**DOCUMENT 00 90 00**  
**ADDENDUM**

**ADDENDUM No.:** 1

**DATE:** March 3, 2023

**RE:** NORTHWOOD TECHNICAL COLLEGE  
RICE LAKE OFFICE RENOVATION  
1900 COLLEGE DERIVE  
RICE LAKE, WISCONSIN 54868  
PROJECT NO. 22039

**A090**

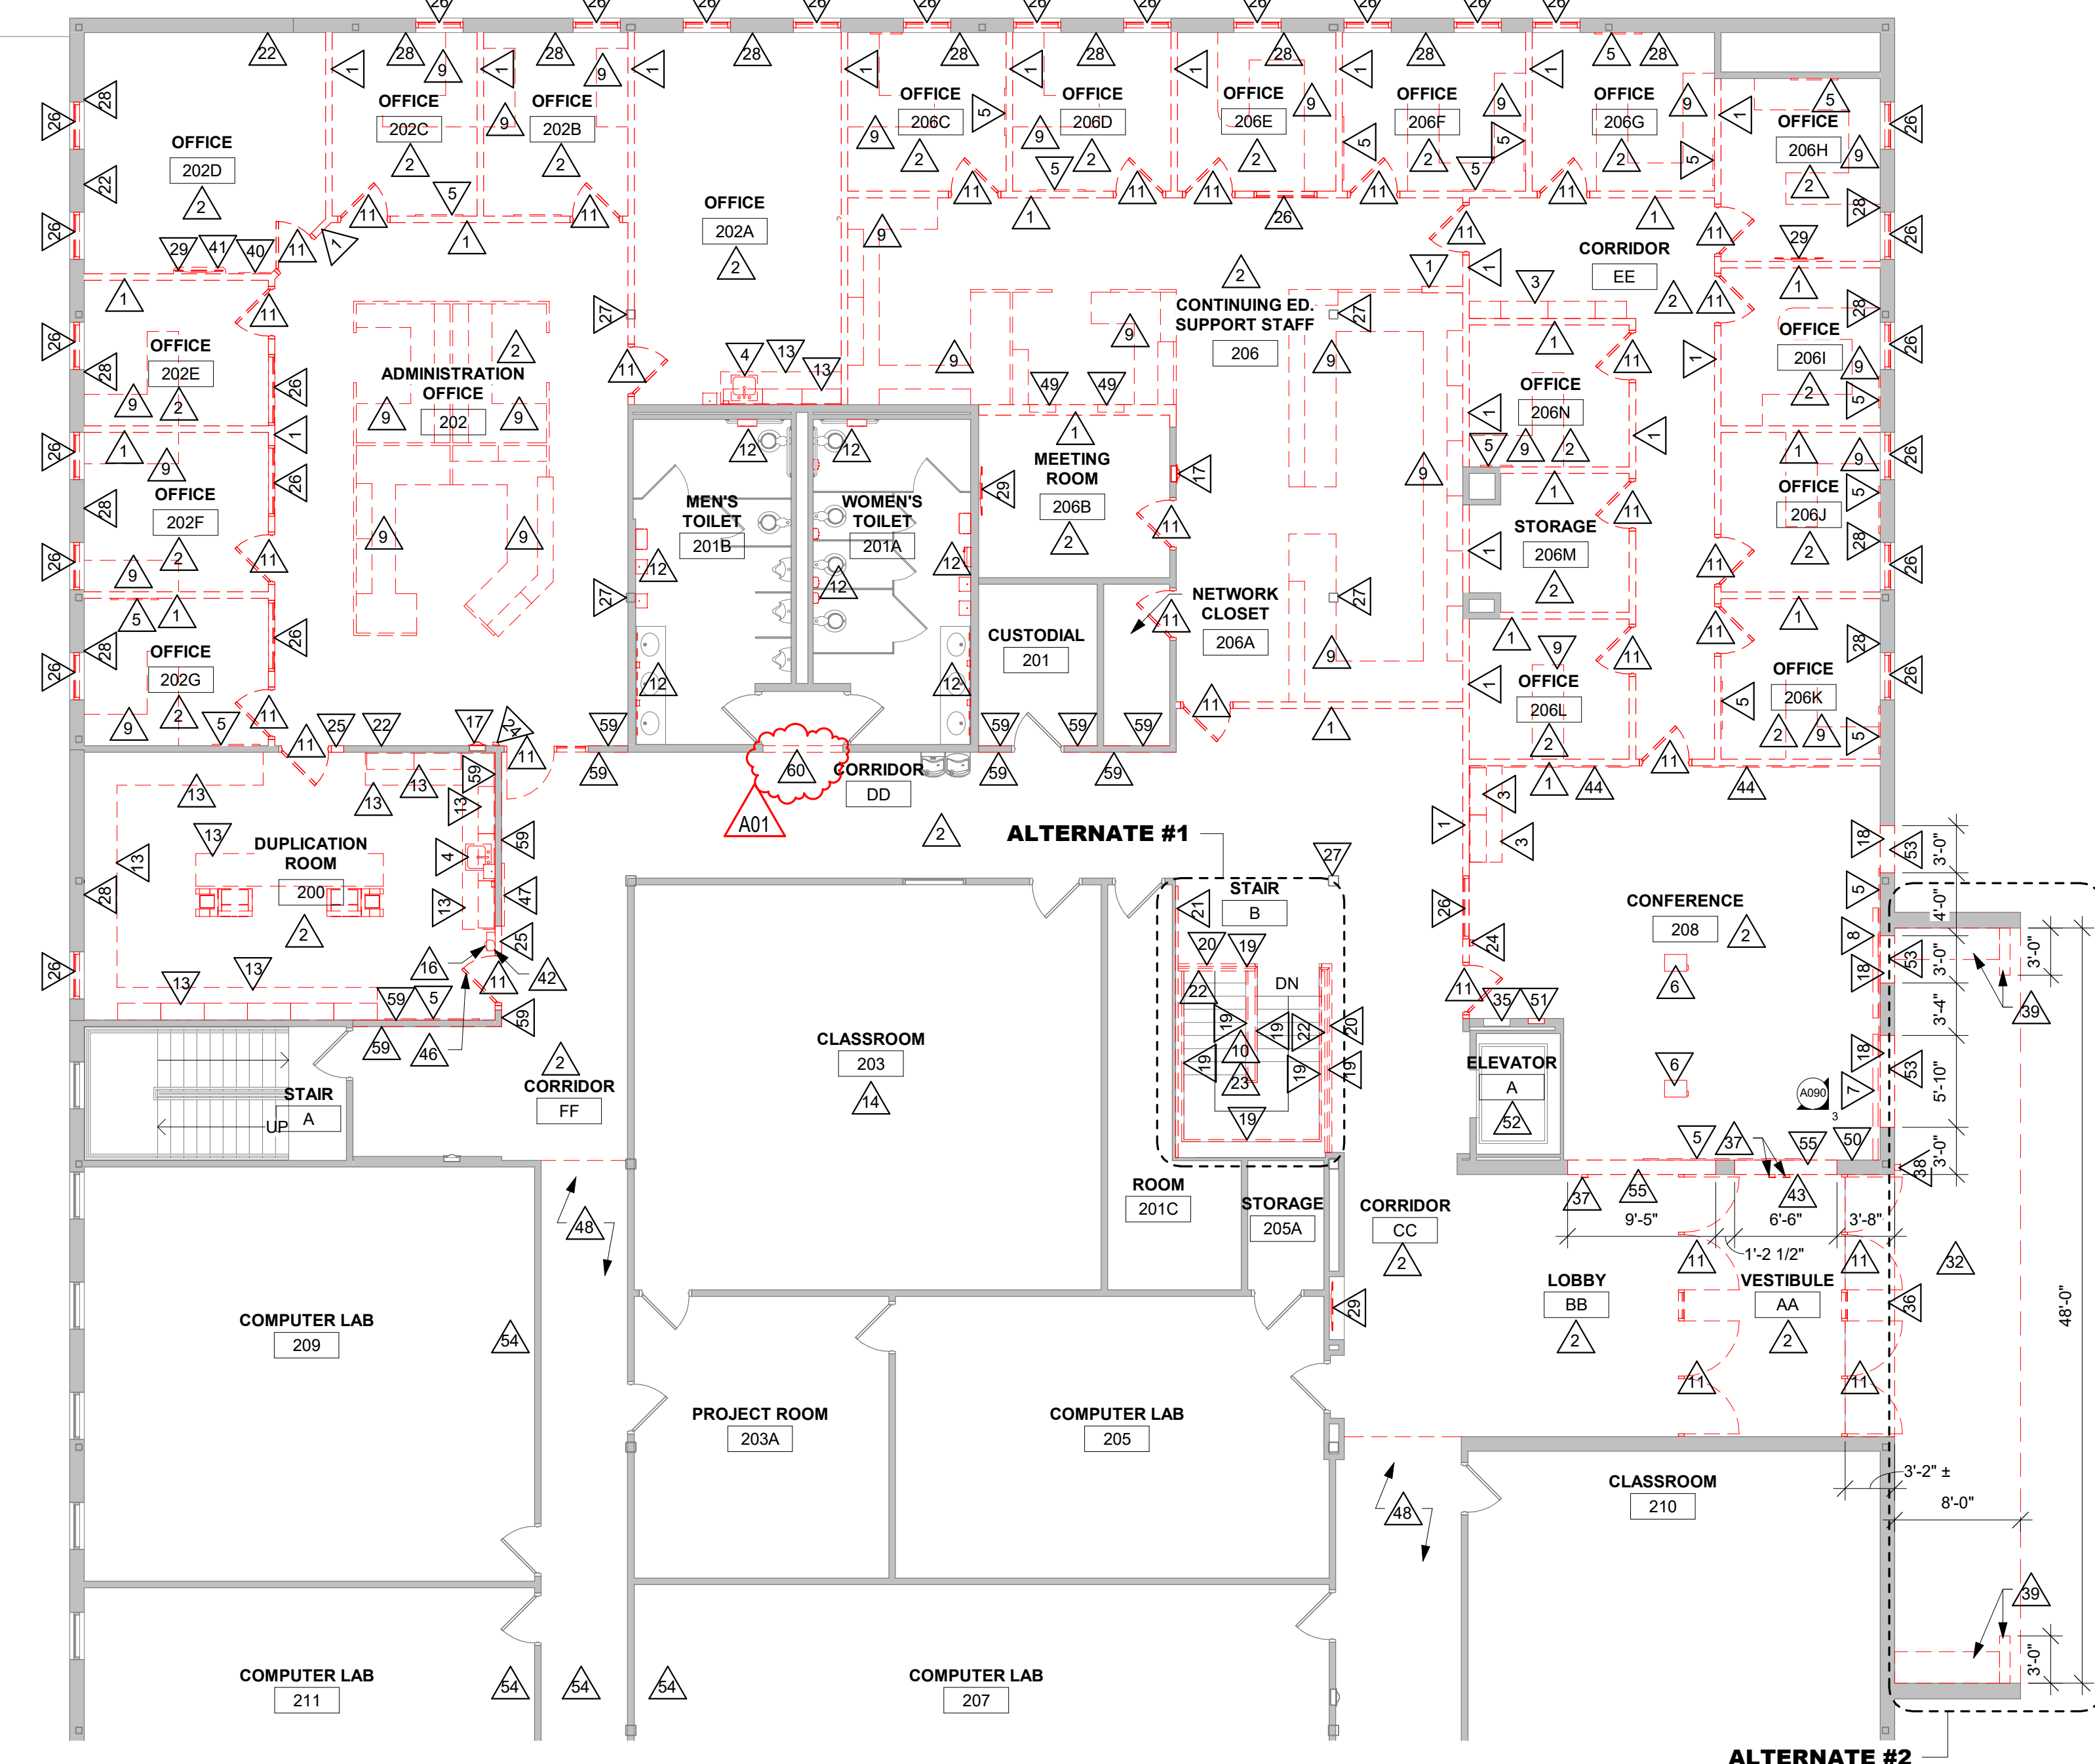
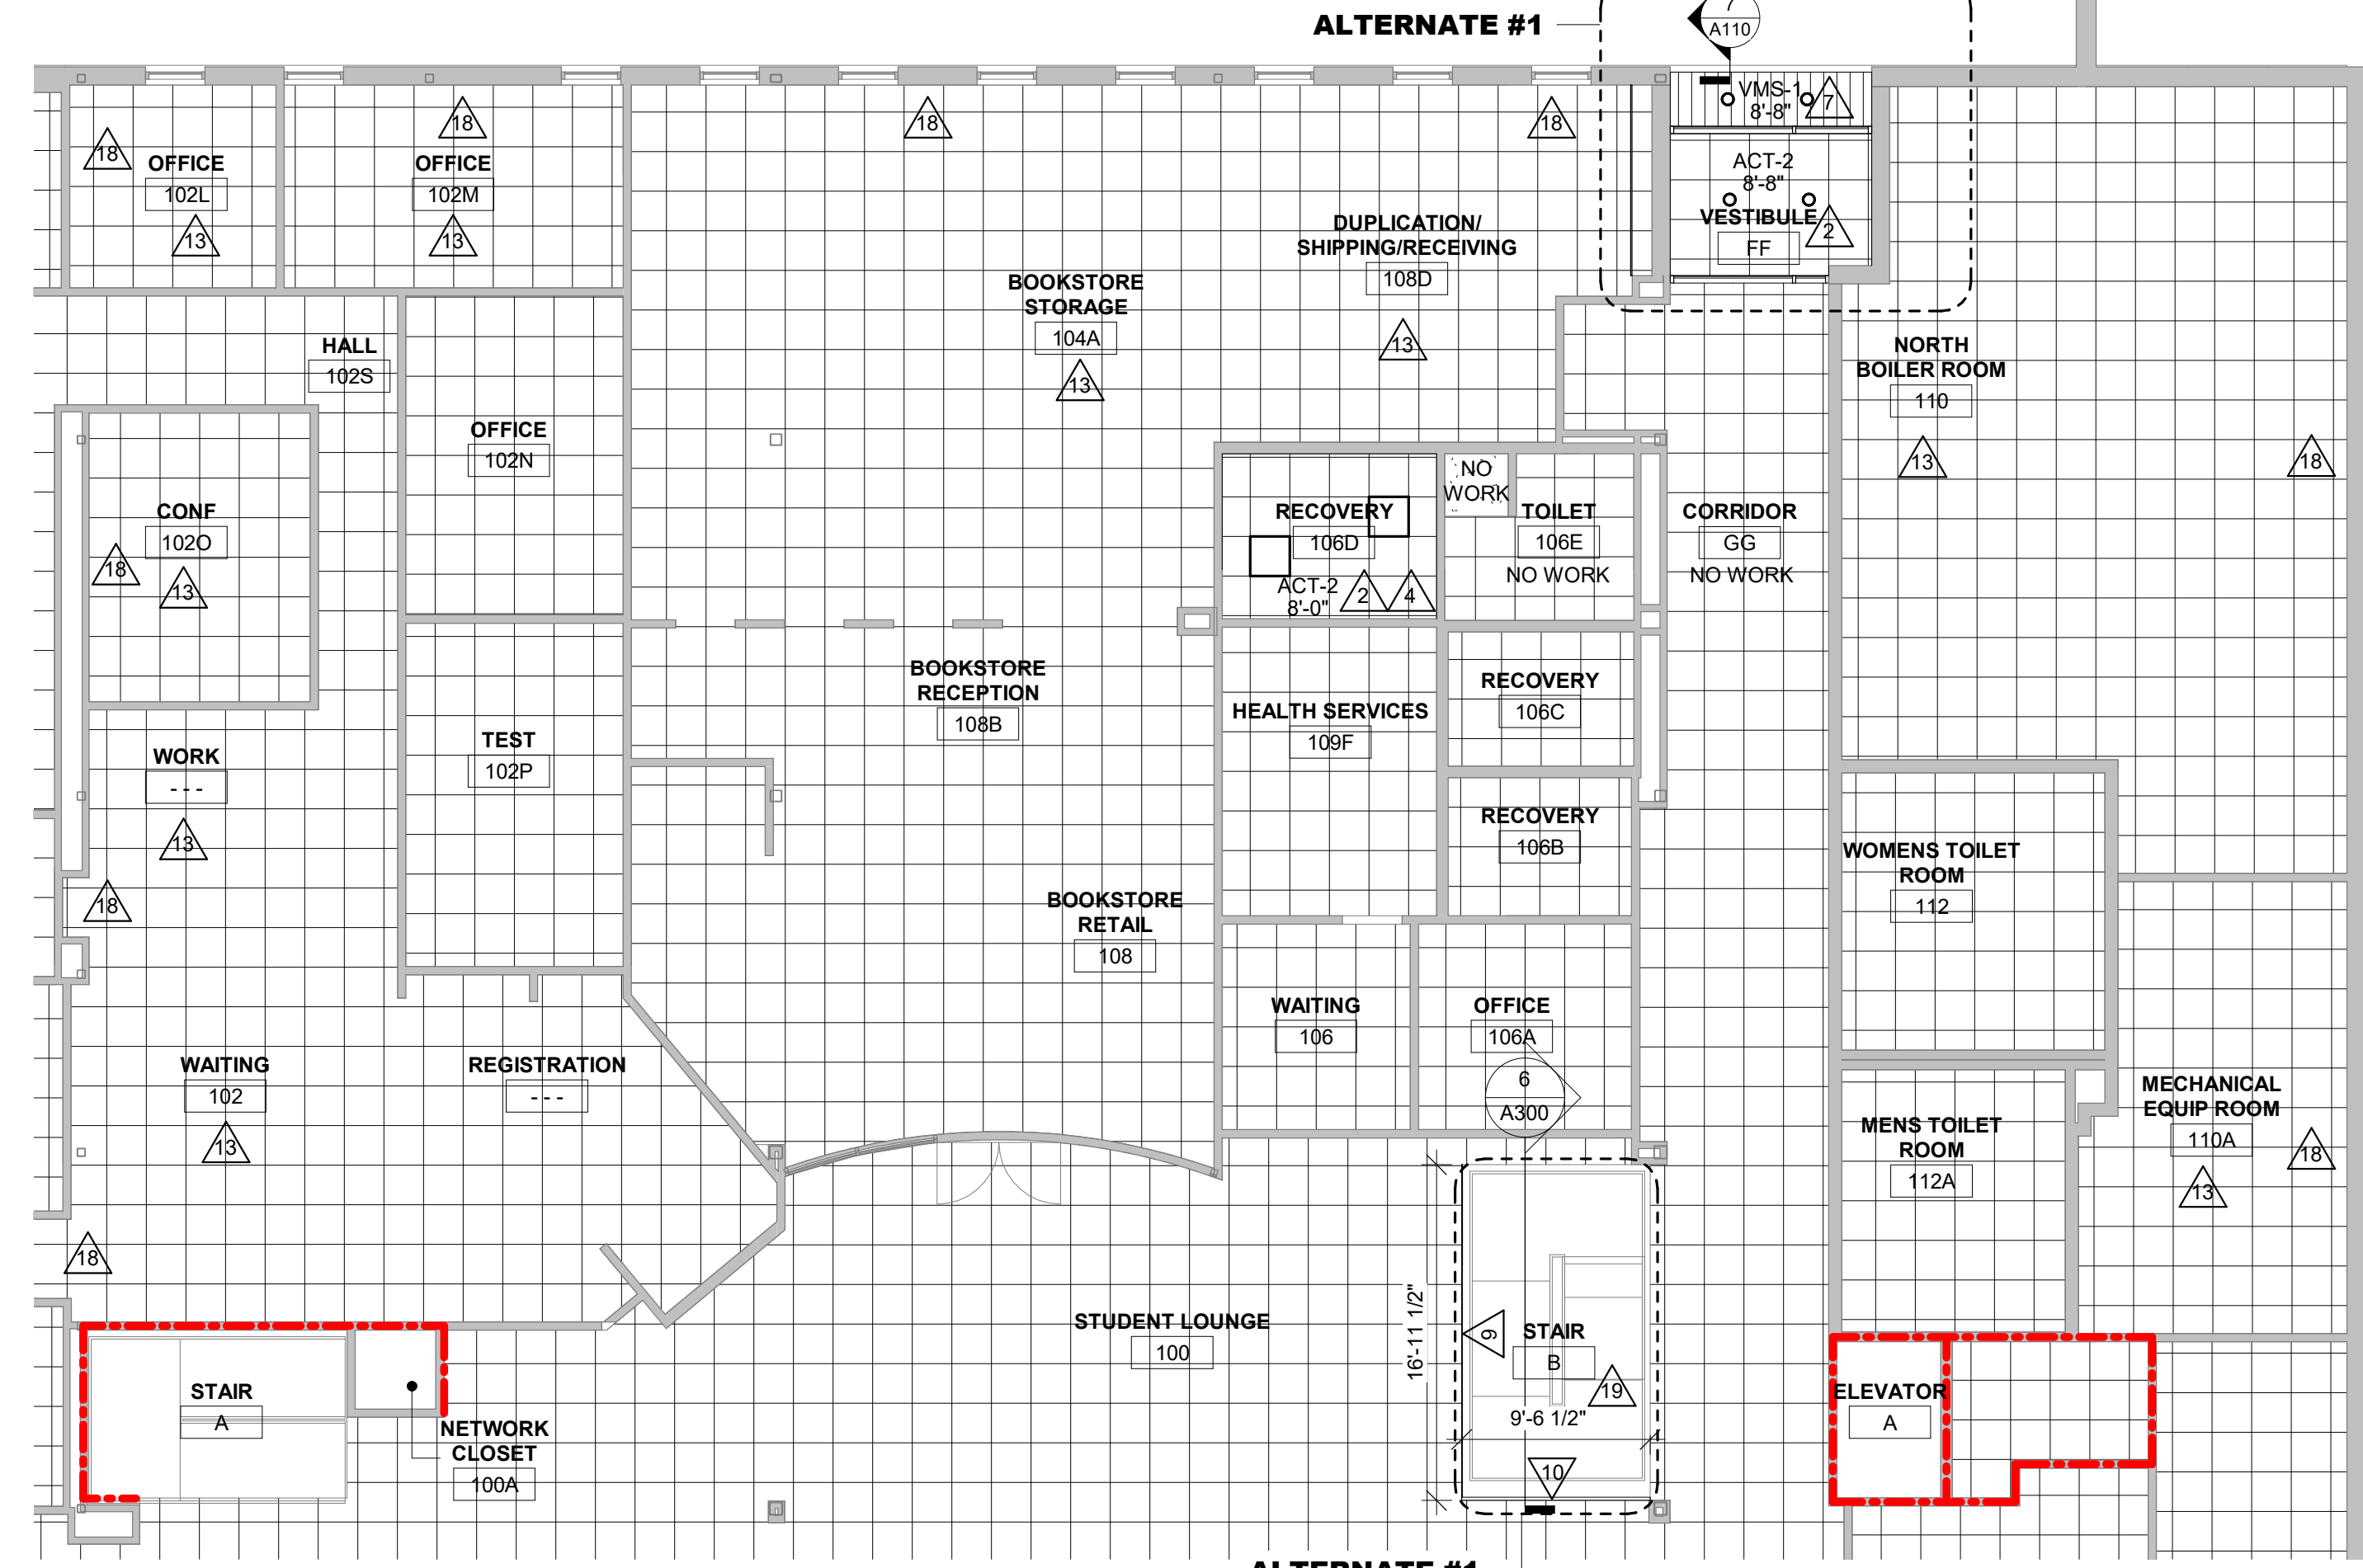
5. Sheet A090 FIRST & SECOND FLOOR DEMOLITION PLANS 30"x42"
  - a. See the revised sheet included in this addendum. Disregard the previous version.
  - b. Revised the description of Key Note 58 to indicate removal and reinstallation of ceiling tile for access to mechanical work be done by the mechanical contractor.
  - c. Added Key Note 60 to require changes at the tile entrance to the toilet rooms.
